LIGO-D961666-B-V

ITEM	QTY.	PART NO.	DESCRIPTION
PART LIST			MATERIAL SPECIFICATION: CRS 12 GA. SHT
UNLESS OTHERWISE SPECIFIED DIMENSIONS ARE IN INCHES TOLERANCES ARE: DECIMALS ANGLES FINISH .XX ± .01 ± 10' 32/ XXX ± .005		CONTRACT OR SALES ORDER NO. JOBNO	
UNSPECIFIED FILETS: R.015 BREAK EDGES .010 ± 45° REMOVE ALL BURRS		APPROX. WT.	
THIRD ANGLE PROJECTION		APPROVALS DATE	
DO NOT SCALE DRAWING		DRAFTER	
CADD FILE NAME		CHECKER	
A103739		ENGINEER	AJL 10/1/96
USED ON		B103740B	
TITLE			FLANGE, CLUTCH PULLEY LIGO G44E, G48E
DWG. NO.			103740
SCALE:			NONE
SHEET			1 OF 1

PSI DWG # 1049-8-550

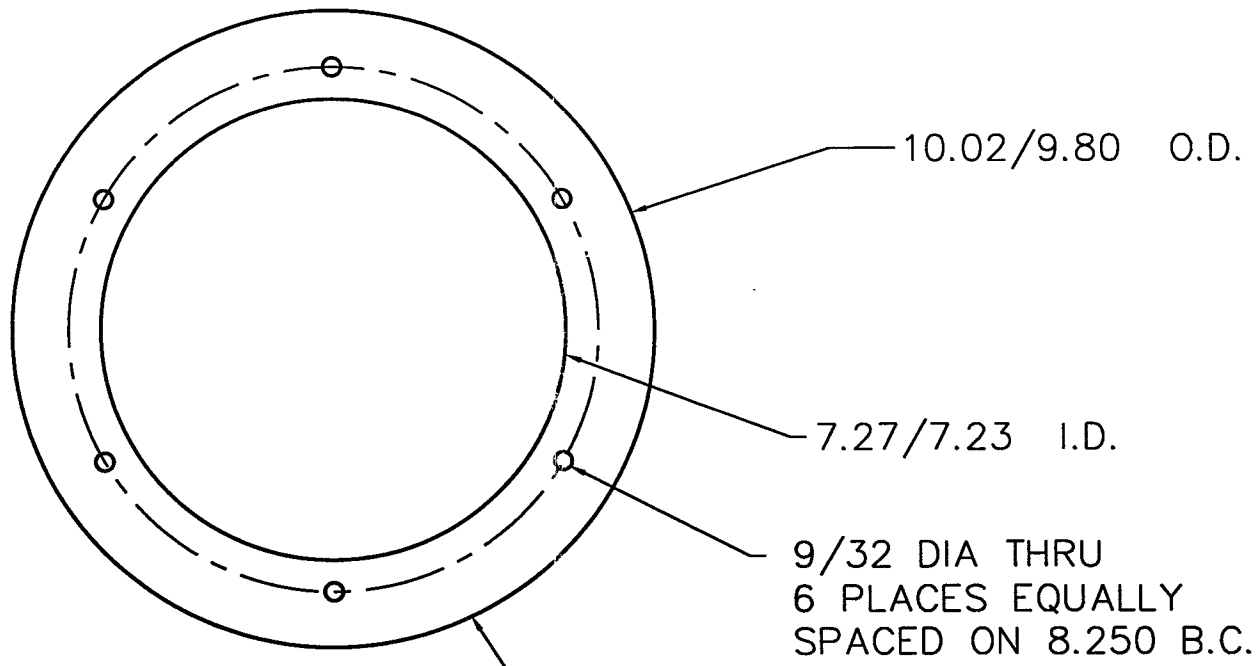
REVISIONS			
REV.	DESCRIPTION	APPROVED	DATE
A	RELEASED	AJL	10/1/96
B	.03 WAS .02	AJL	10/18/96

— .03
